GLEN AT WIDEFIELD FILING NO. 9
SPRING GLEN DRIVE (Sta. 30+00 to Sta. 43+00)
PLAN AND PROFILE
EL PASO COUNTY, COLORADO

Project No.:	17038
Date:	December 15, 2017
Design:	AWMc
Drawn:	JAK
Check:	AWMc
Revisions:	
SHEET	2

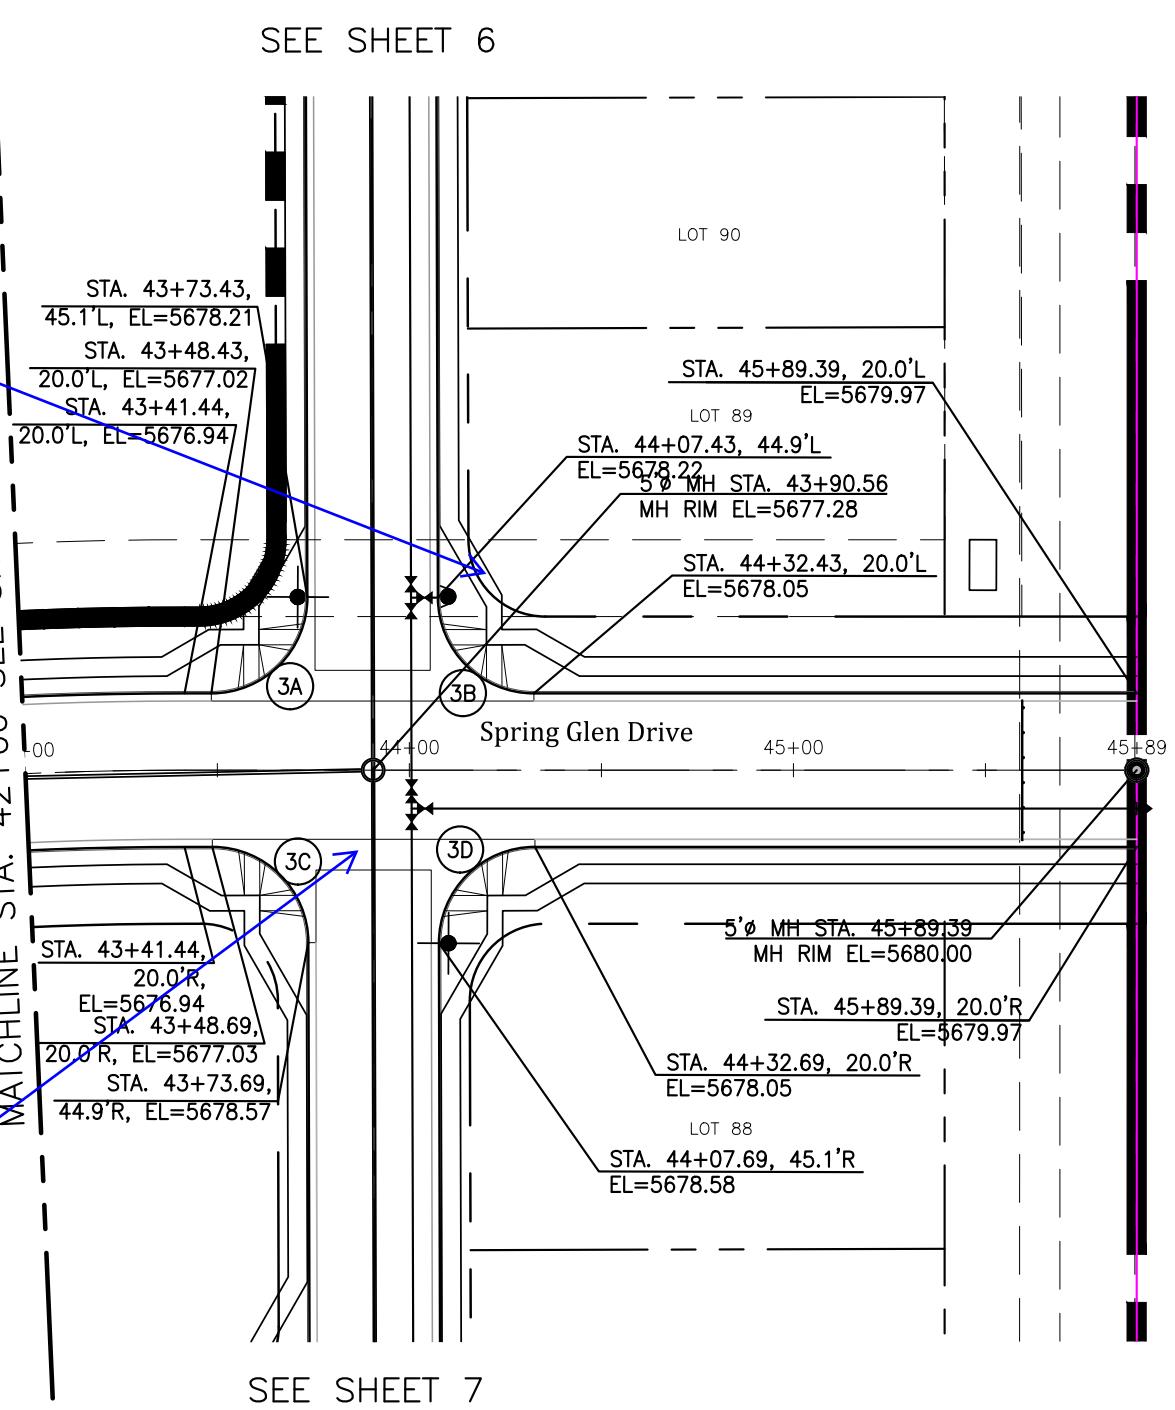
Adjust ROW at intersections so the sidewalks are completely the ROW.

Identify the width/thickness of the crosspan at all locations. The cross pan detail notes different width and thickness depending on the road classification.

update street names.

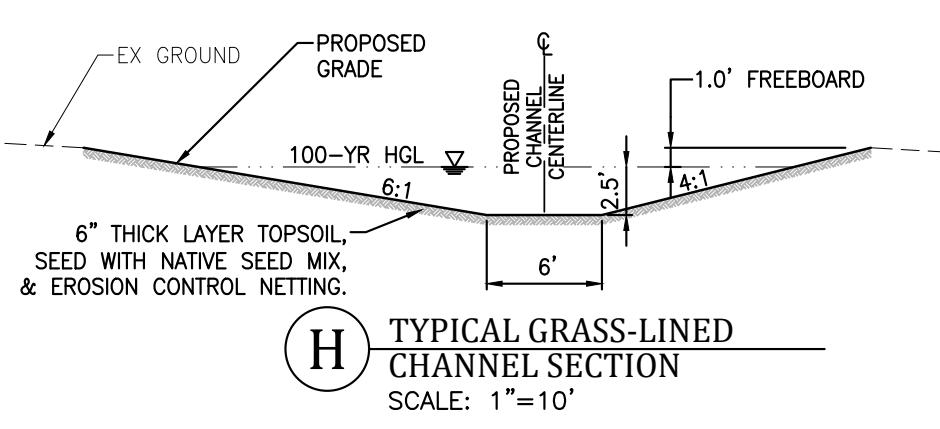
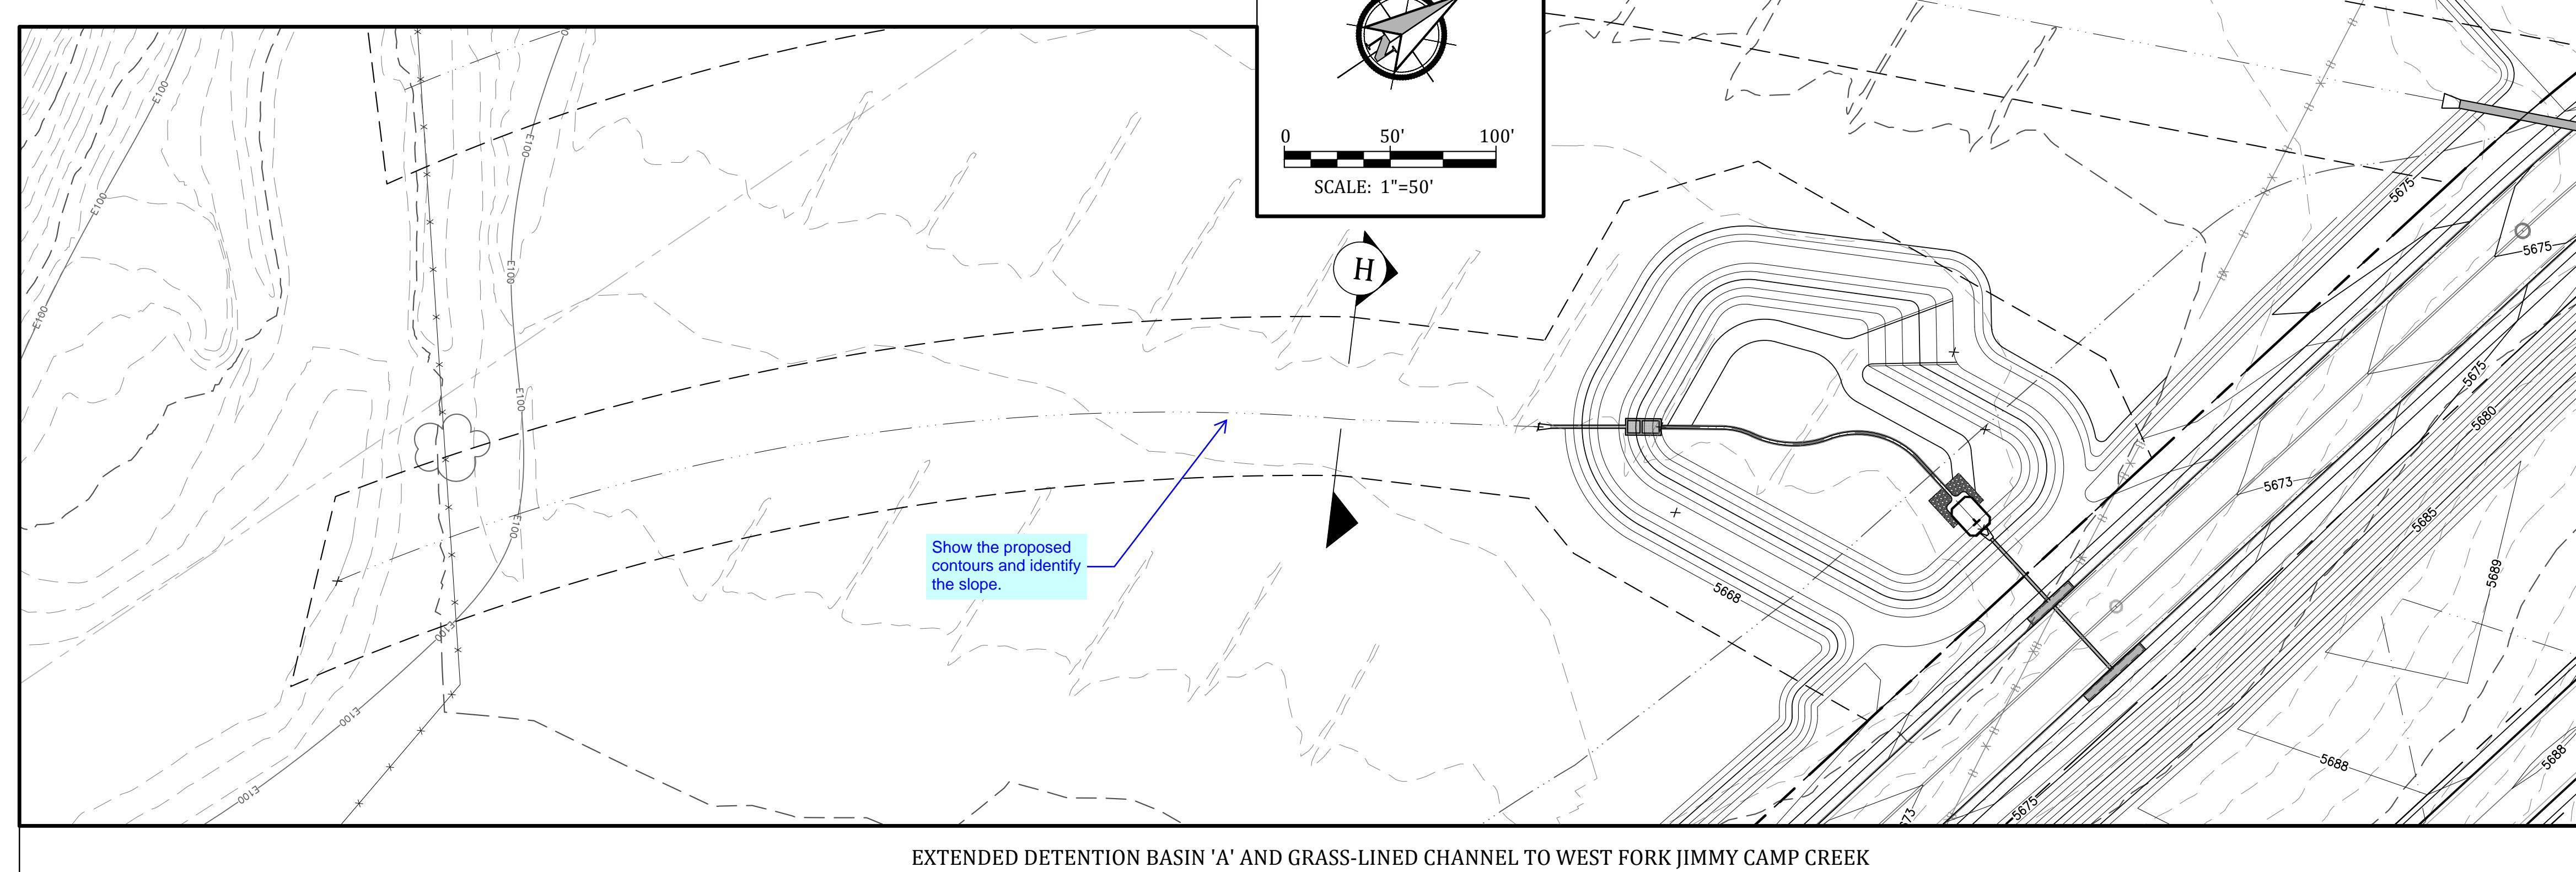
Pipe Diameter and height above pipe invert does not match the drainage report
UD-Detention calculation. Update one or the other to match.
